Refinements to the Frequency Hop CCA Criteria

Jim McDonald
Motorola Inc.
50 E Commerce Dr.
Schmumburg, IL 60173
708 576 3169
jim_mcdonald@wca.mot.com

Two level, 1 Mb/s, “On Channel” Signal

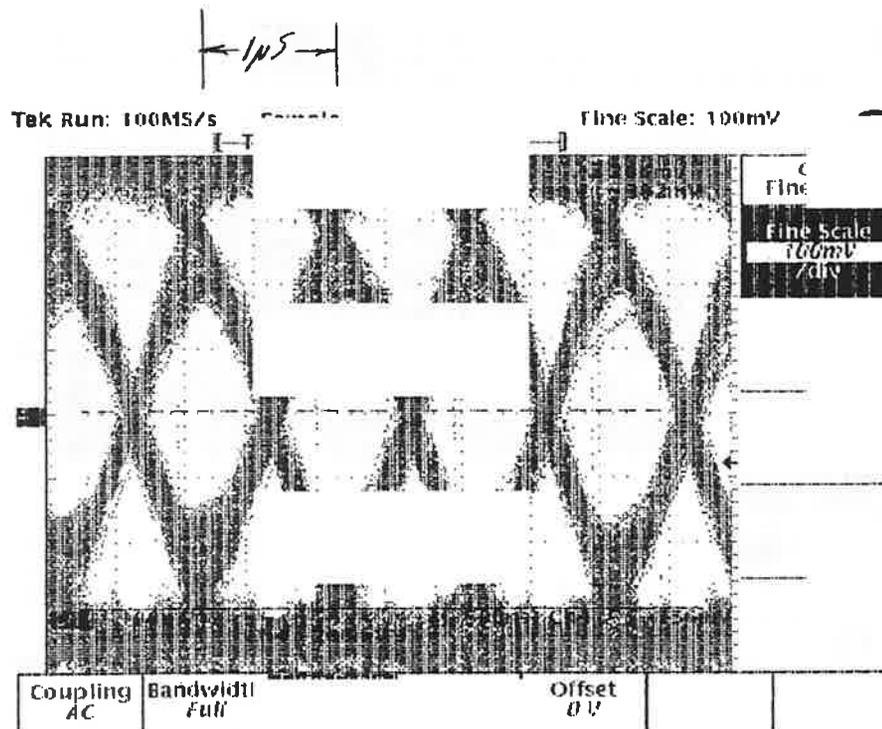
- CCA based on Amplitude Only
- CCA based on Amplitude in Combination with Pattern Recognition
 - “on channel” two level, 1 Mb/s, 802.11 Frequency Hop signals
 - “on channel” four level, 2 Mb/s, 802.11 Frequency Hop signals

- **What feature of the two level and four level signals is distinctive enough for a simple, low cost, receiver to positively identify either waveform?**
- **The answer escapes the author.**
- **The requirement for the Frequency Hop PHY to defer to pseudorandom data is a problem in terms of requiring either:**
 - **high cost, high power consumption circuits, or**
 - **excessive deferrals.**

BSS
One Access Point and Three Portables

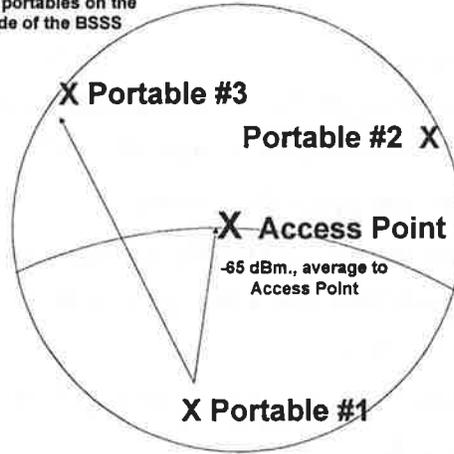
- **Case 1: All Signal sources from the same BSS**
 - **If the Access Point is transmitting, then there is no problem**
 - **If a Portable is transmitting there is a potential for a problem as illustrated on next slide**
 - **The answer to this problem is RTS/CTS, not CCA**

- **Portable 1 starts a transmission, Signal A, to the Access Point**
- **Portable 2 doesn't recognize this as requiring CCA deferral, its too low in amplitude**
- **Portable 3 now sees the situation depicted in Figure 1**
